SERVICE BULLETIN

BOEING DC-10 (SERIES 10, 30, AND 40), KC-10A, DC-10-30F (KDC-10),
MD-10 (SERIES 10 AND 30), AND MD-11

Bulletin No. 60-847-28-2
ATA 28-22

FUEL BOOSTER PUMP — PUMPING UNIT — INSPECTION TO DETECT IMPROPER FUEL PUMP INTERNAL LEAD WIRE ROUTING

Acceptable Pumping Units
Figure 1

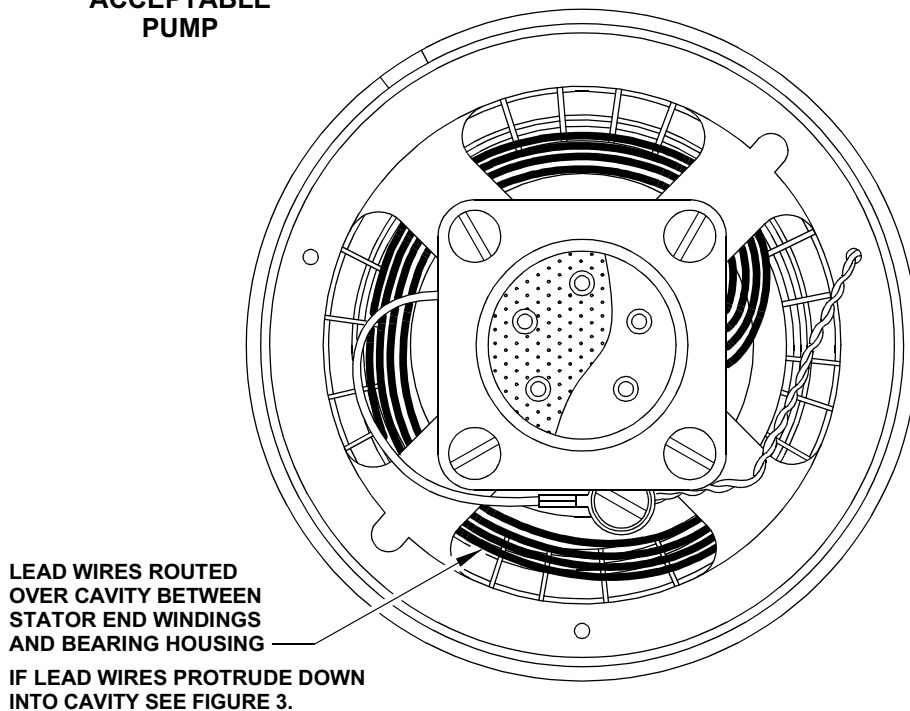
- (1) Visually check the stator lead wire routing through the four (4) slots in the connector support assembly as shown in Figure 1.
- (2) The preferred routing will have the lead wires coiled and resting on top of the stator windings (some wires may be obscured by the outer edge of the connector support) and not protruding down into the cavity between the bearing housing on the connector support assembly and the stator end windings (See Figure 1). Pumps with the lead wires in this condition are acceptable.

- (3) Pumps with a portion of the wires routed over the cavity and not protruding down into the cavity between the bearing housing on the connector support assembly and the stator end windings are acceptable (See Figure 1).

**Unacceptable Pumping Unit
 Figure 2**

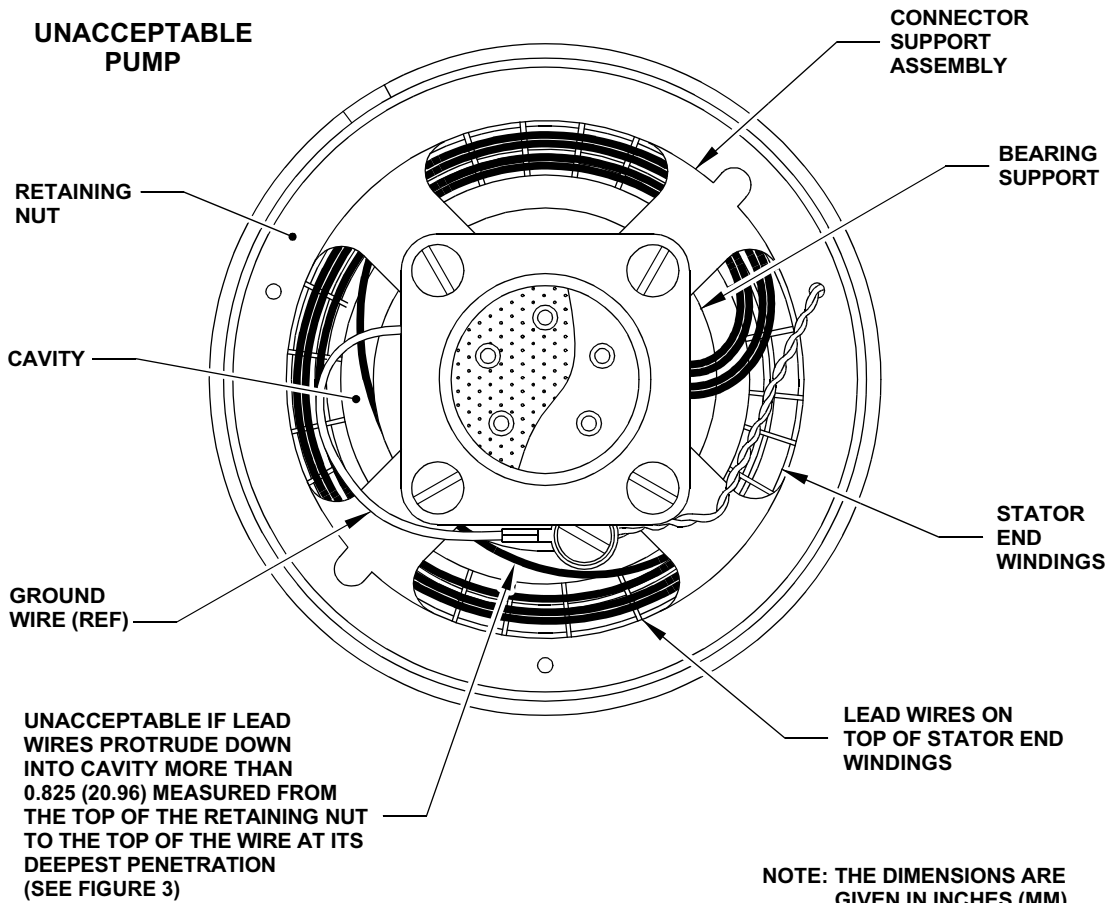
- (4) On pumps with a wire or wires protruding down into the cavity (Figure 2), determine the extent to which the wire(s) protrude down into the cavity, as follows:

- (a) If there are multiple wires in the cavity, the lower-most one must be visible and accessible for inspection. Use a non-metallic, non-wooden tool (because of the possibility of splintering) to gently move the upper wires so the lowest wire is exposed. Use care not to damage the wire insulation. IF THE WIRES ARE ROUTED SUCH THAT THEY CANNOT BE MOVED TO ALLOW ACCESS TO THE LOWEST WIRE IN THE CAVITY, THE ASSEMBLY MUST BE REJECTED AND THE LEAD WIRE ROUTING CORRECTED.

Measurement of Lead Wire Position
Figure 3

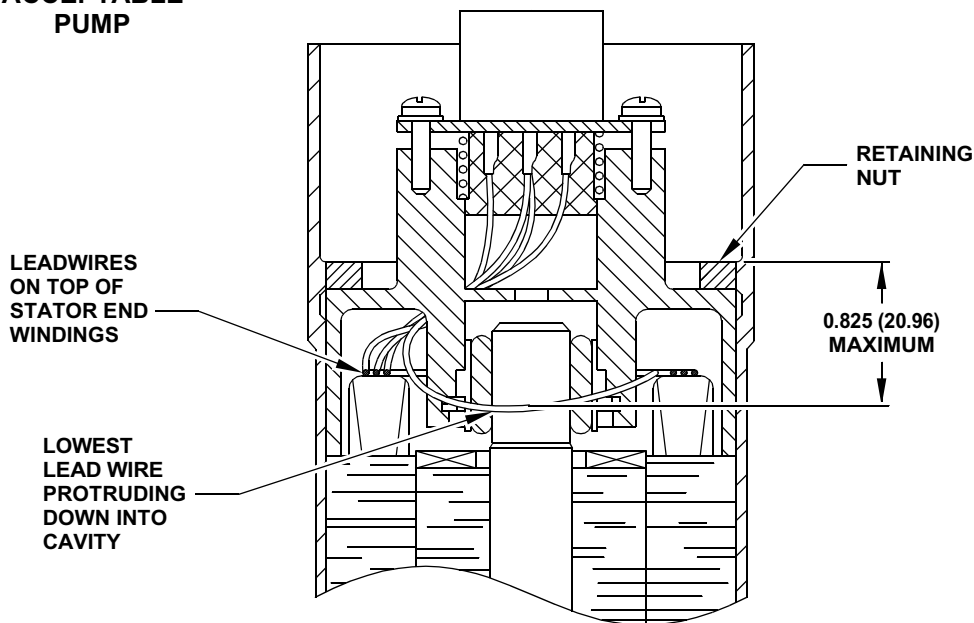
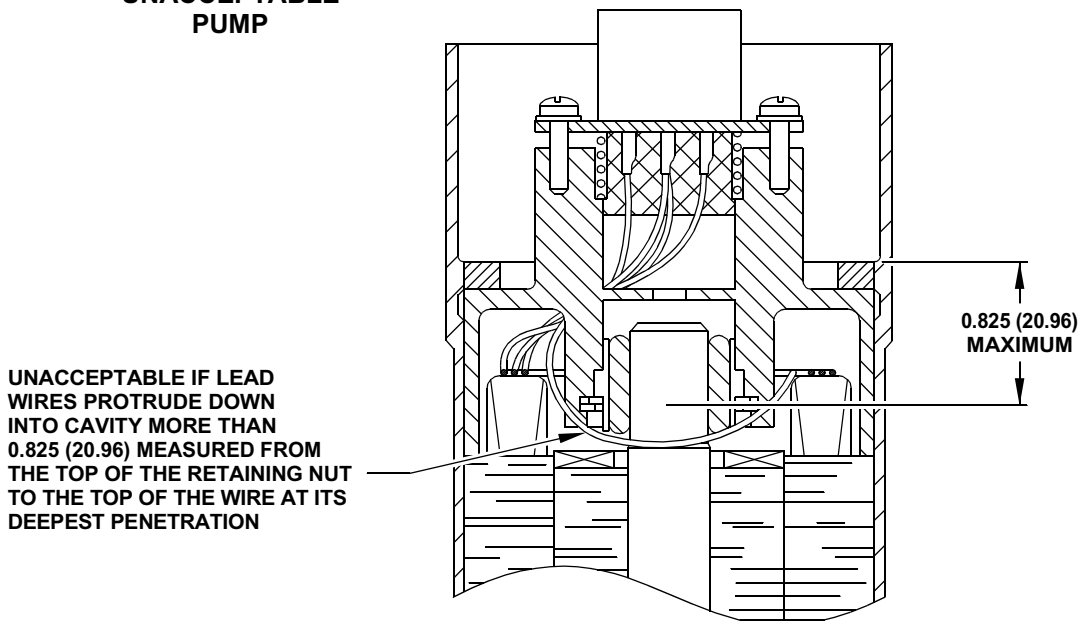
- (b) Carefully use a non-metallic, non-wooden measuring tool similar to that shown in Figure 4 to verify that the lowest portion of the loop on the lowest wire does not protrude down into the cavity between the bearing housing on the connector support assembly and the stator end windings more than 0.825 inch (20.96 mm) maximum when measured from the surface of the retaining nut down to the top of the lead wire (see Figure 3). Any lead wire that protrudes down into the cavity less than 0.825 inch (20.96 mm) is acceptable.

- (c) ANY LEADWIRE THAT PROTRUDES DOWN INTO THE CAVITY BETWEEN THE BEARING HOUSING ON THE CONNECTOR SUPPORT ASSEMBLY AND THE STATOR END WINDINGS MORE THAN 0.825 INCH (20.96 MM) WHEN MEASURED FROM THE SURFACE OF THE RETAINING NUT DOWN TO THE TOP OF THE LEADWIRE IS UNACCEPTABLE AND MUST BE REJECTED AND THE LEAD WIRE ROUTING CORRECTED.

- (d) IF THE LOWEST POINT OF THE WIRE PROTRUDING DOWN INTO THE CAVITY CANNOT BE MEASURED, THE PUMP MUST BE REJECTED AND THE LEAD WIRE ROUTING CORRECTED.

**Measurement Tool
Figure 4**

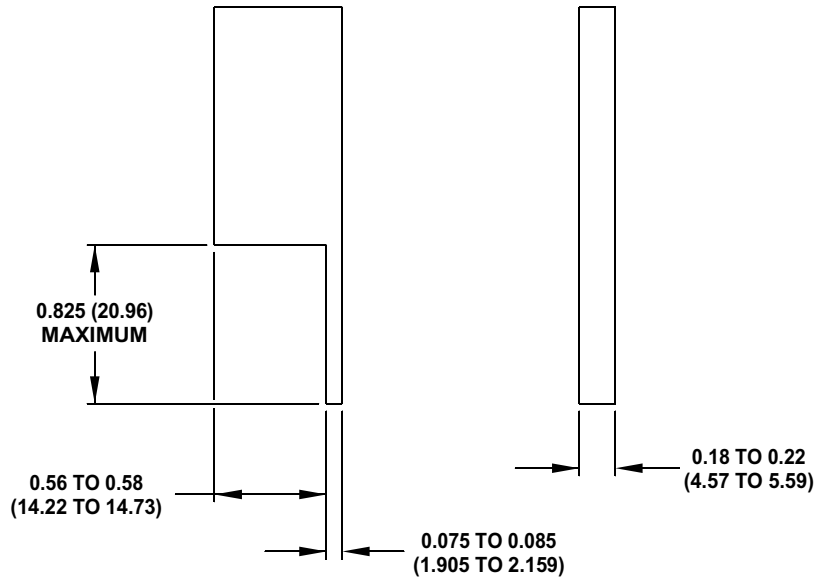
- ① ROUND OFF CORNERS AND SHARP EDGES.
- ② MANUFACTURE FROM NON-METALLIC, NON-WOOD MATERIAL.
